Technical Service Bulletin

Transaction No.: **2082910/1**

27 Warning message in instrument cluster: P0A1F00 battery control unit

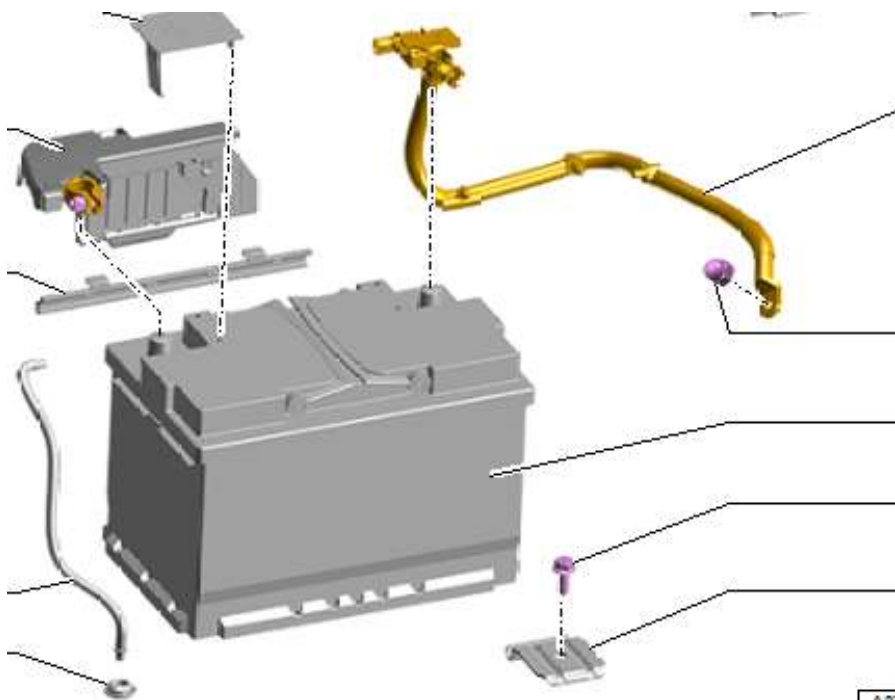
- Replace the BDM (battery monitor control unit, manufactured by Continental) with a BDM manufactured by Hella according to the following list:

Audi A6 / A7 models: 4K0.915.181.D (Continental) to be replaced by 8S0.915.181.D (Hella)

Audi A8 models: 4N0.915.181.E (Continental) to be replaced by 8W0.915.181.F (Hella)

Audi Q7 / Q8 models: 4K0.915.181.E (Continental) to be replaced by 8S0.915.181.D (Hella)
